Access Compliance Report Public Rights-of-Way (Curb Ramps)

Main Street: CRESTVIEW Cross Street: HILLSIDE_DR Location: SW

ADA ID: RPRK211018180247 Ramp Type: Type 4 - Parallel Initial Pass/Fail: Fail Overall Compliance: No Severity Score: 34

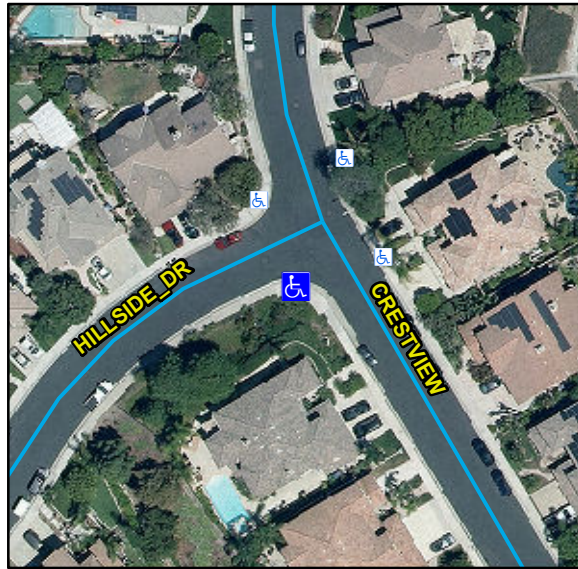
Compliance	Description	Data	Compliance	Description	Data
N/A	Ramp Length LT (in)	92	N/A	Ramp Length RT (in)	92
No	Ramp Width LT (in)	42	No	Ramp Width RT (in)	42
Yes	Ramp Run Slope LT (%)	7.4	Yes	Ramp Run Slope RT (%)	5.3
No	Ramp Cross Slope LT (%)	14.9	No	Ramp Cross Slope RT (%)	10.6
N/A	Landing Present	N/A	N/A	DWS Provided	N/A
N/A	Landing Length (in)	N/A	N/A	DWS Contrast	N/A
N/A	Landing Width (in)	N/A	N/A	DWS Length (in)	N/A
N/A	Landing Run Slope (%)	N/A	N/A	DWS Full Width	N/A
N/A	Landing Cross Slope (%)	N/A		DWS Offset Type	N/A
N/A	Landing Movement Obstructed?	N/A	N/A	DWS Offset Left (in)	N/A
	Landing Movement Type	N/A	N/A	DWS Offset Right (in)	N/A
N/A	Landing Shared	N/A			
N/A	Clear Space	Yes			
N/A	Clear Space To Crosswalk (in)	N/A			
N/A	Marked Crosswalk 1	No	N/A	Marked Crosswalk 2	No
	Crossing 1 Direction	E		Crossing 2 Direction	N
	Marked Crosswalk 1 Width (in)	N/A		Marked Crosswalk 2 Width (in)	N/A
N/A	Ramp Inside Crosswalk 1	N/A	N/A	Ramp Inside Crosswalk 2	N/A

Crossing 1 Slope (%)	0.1		Crossing 2 Slope (%)	3
	Crossing 1 Cross Slope (%)	7.5		Crossing 2 Cross Slope (%)	5.4
N/A	Gutter Ponding	N/A	N/A	Curb Slope	4.2
No	Gutter Lip Height (in)	0.25		Road Run Slope (%)	7.7
N/A	Gutter Run Slope (%)	N/A		Road Cross Slope (%)	2.6
N/A	Gutter Cross Slope (%)	N/A	No	Perpendicular Joint Present	No
Yes	Overall Surface Condition	Acceptable			
	Cross Gutter Present?	No		Spandrel Present?	No
	Replace Cross Gutter?	N/A		Replace Spandrel?	N/A

Remove & Replace Curb Ramp With Two New Directional Ramps or Equivalent. Grind Gutter Lip.
